VIRTUAL MEETING OF THE BIRMINGHAM PLANNING BOARD
WEDNESDAY, FEBRUARY 24, 2021
7:30 PM

Re: Special Land Use Permit Amendment and Revised Final Site Plan for Triple Nickel at 555 S. Old Woodward to allow a change of ownership, change of name to Birmingham Pub, and Revised Final Site Plan

On February 3, 2021, the owners of Triple Nickel submitted an application for a Special Land Use Permit Amendment ("SLUP") and Revised Final Site Plan and Design Review ("FSP") for approval to transfer ownership of the existing restaurant operating under an economic development license, to change the name of the restaurant, add new signage and awnings and make minor changes to the interior of the restaurant.

Woodward Avenue - East Elevation

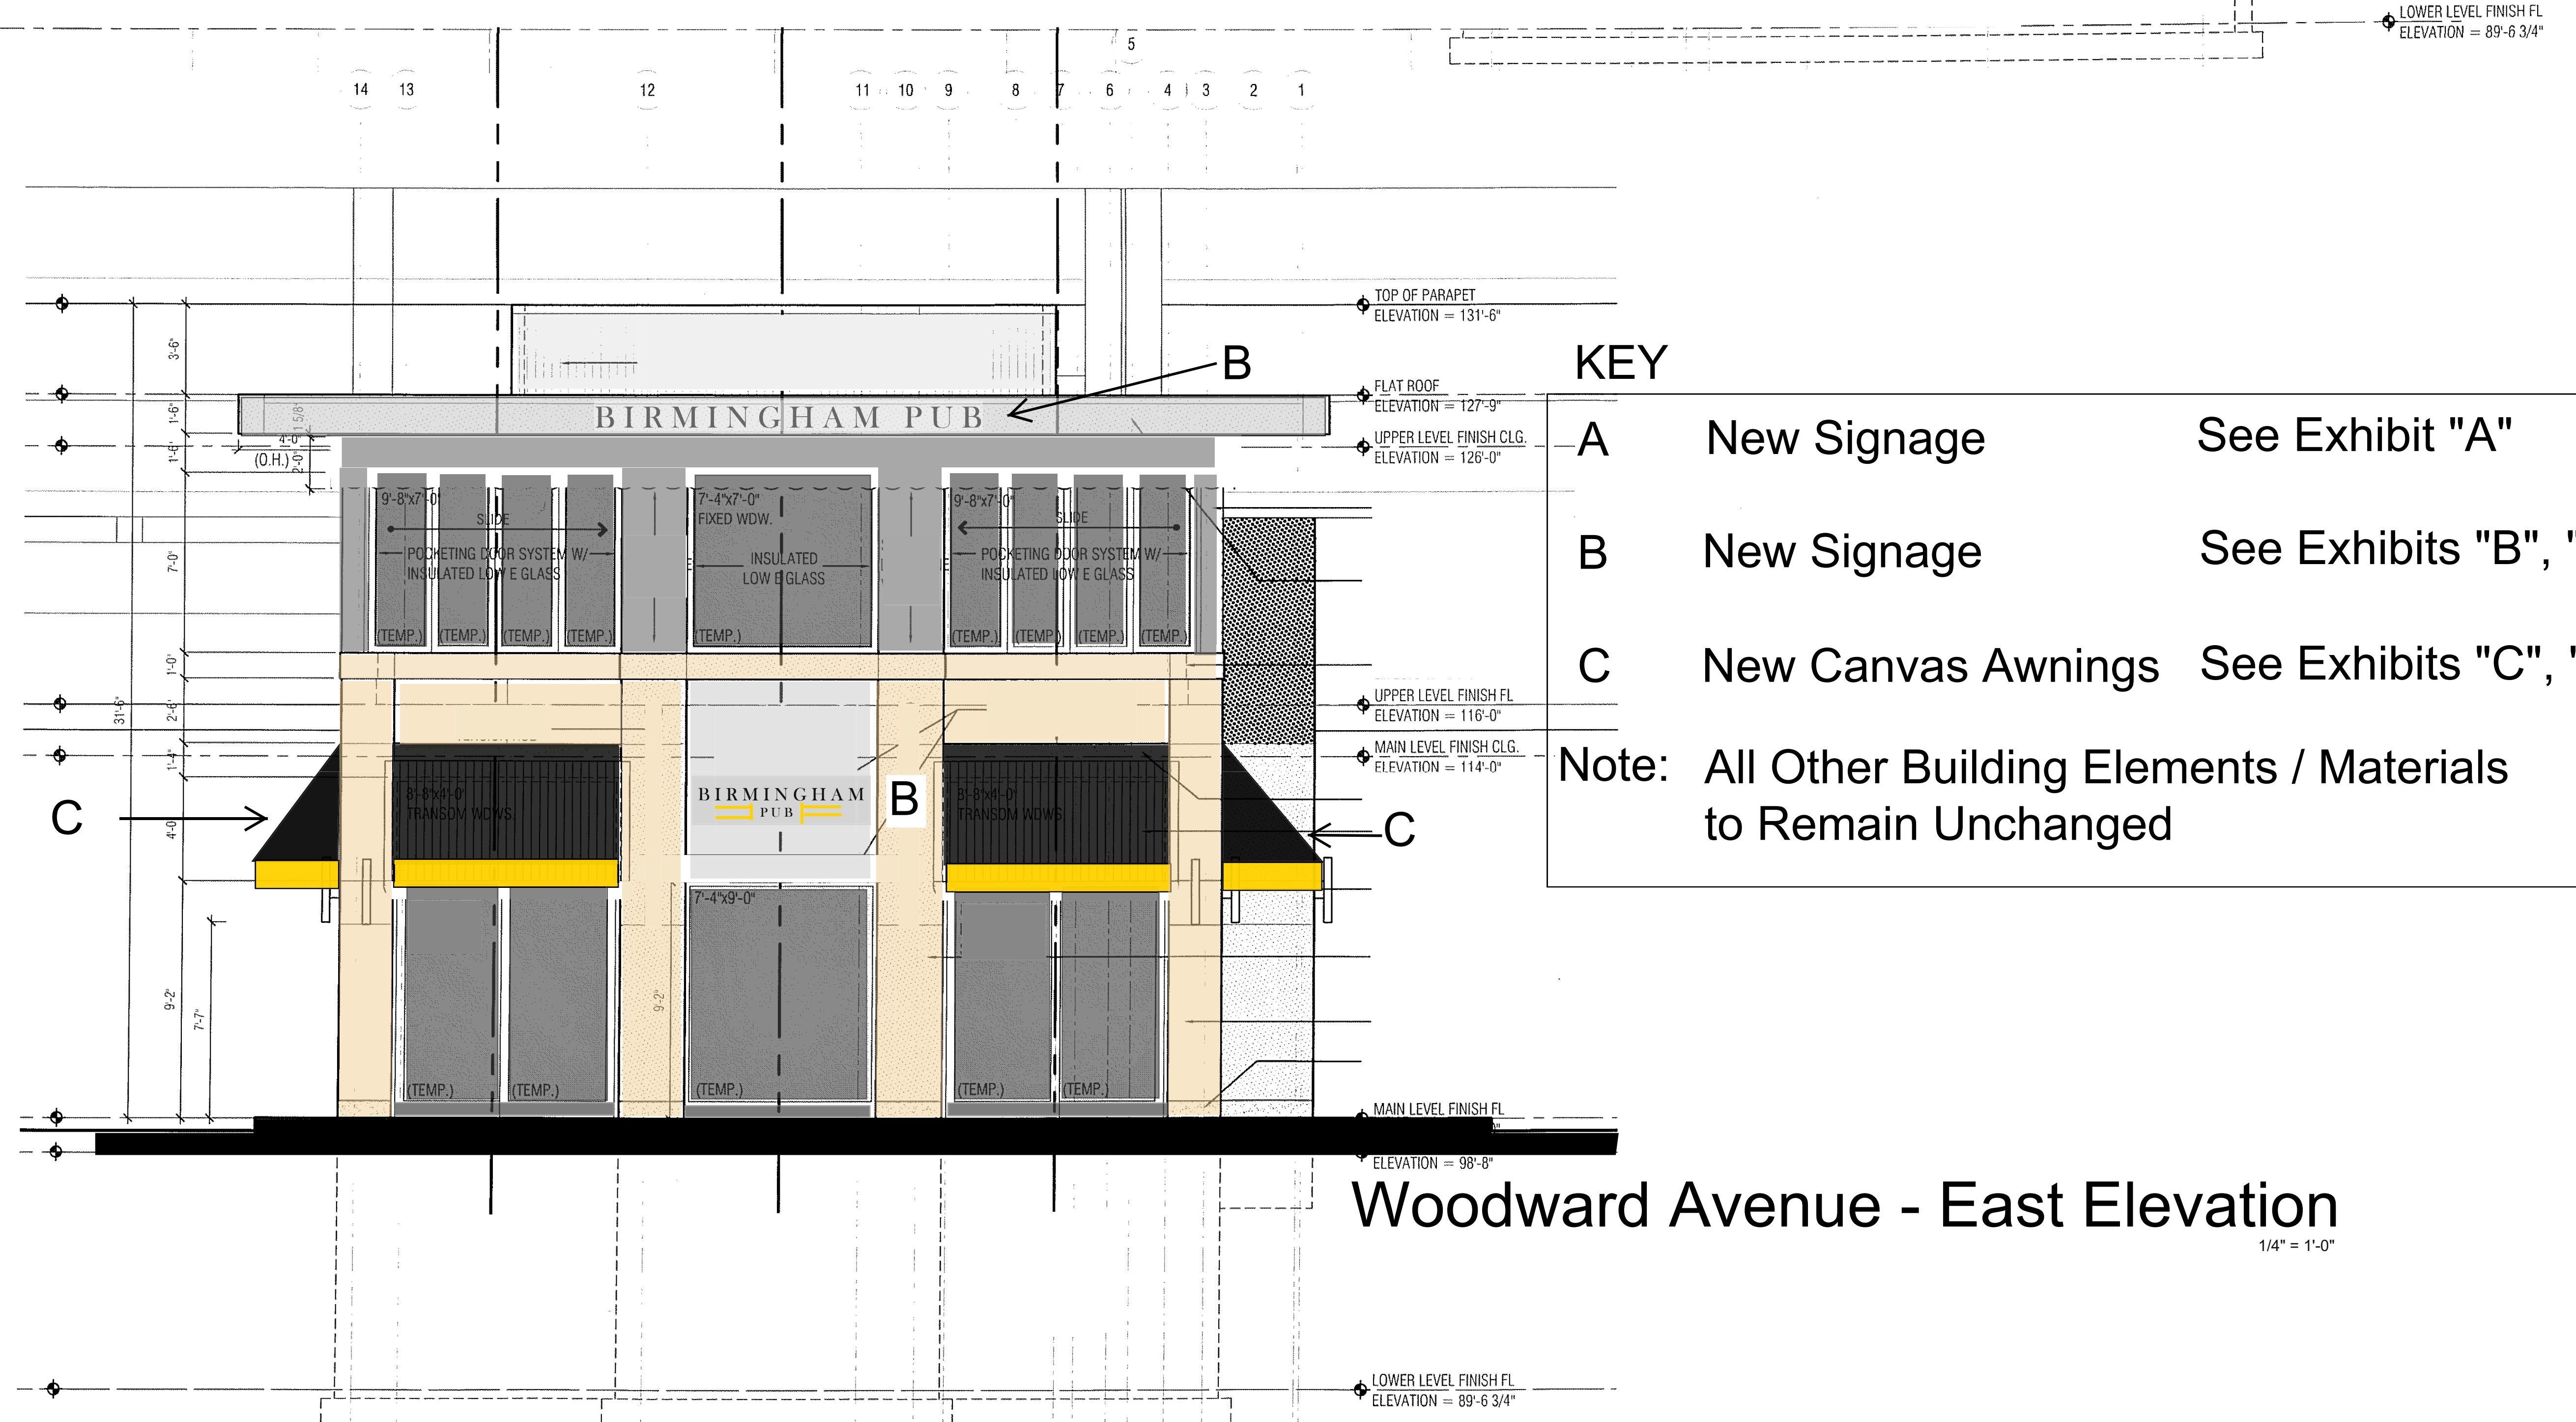
However, the Sign Ordinance also provides that the Planning Board may designate an alternate horizontal building width as the principal building frontage for the purpose of signage. Triple Nickel was previously approved to use the Bowers elevation as the principal building frontage. The Bowers elevation is 110.25' in length, thus permitting a total of 110.25 sq.ft. of total signage on the building, should the Planning Board wish to re-designate the Bowers elevation as the principal building frontage.

If the Planning Board approves the Bowers elevation as the principal building frontage, then the proposed signage is within the total signage limit. If however the Planning Board does not feel that it is appropriate to designate Bowers as the principal building frontage, then the applicant will be required to reduce the overall building signage by 47.76 sq.ft.

In accordance with section 1.05(K)(2) of the Sign Ordinance, building identification signage is permitted above the first floor sign band if non-illuminated. However, the proposed building identification signage on Woodward Avenue is proposed to be illuminated with internally lit led (blue) and halo lit (white) channel letters. **Illumination of such signage is not permitted. The applicant will be required to remove the proposed illumination or obtain a variance from the Board of Zoning Appeals.**

Finally, as noted in the chart above, the applicant is required to provide material, color and lighting details for all signage.

- (1) The Planning Board designates the Bowers elevation as the principal building frontage or the applicant reduces the overall building signage by 47.76 sq. ft.;
- (2) The applicant remove the proposed illumination from the building identification sign on Woodward Avenue or obtain a variance from the Board of Zoning Appeals;
- (3) Applicant provide all material, color and lighting specifications for all signage; and
- (4) Applicant execute a revised contract with the City of Birmingham outlining the nature of the proposed operation of Birmingham Pub and approving the use of the existing Economic Development liquor license under the new name Birmingham Pub.
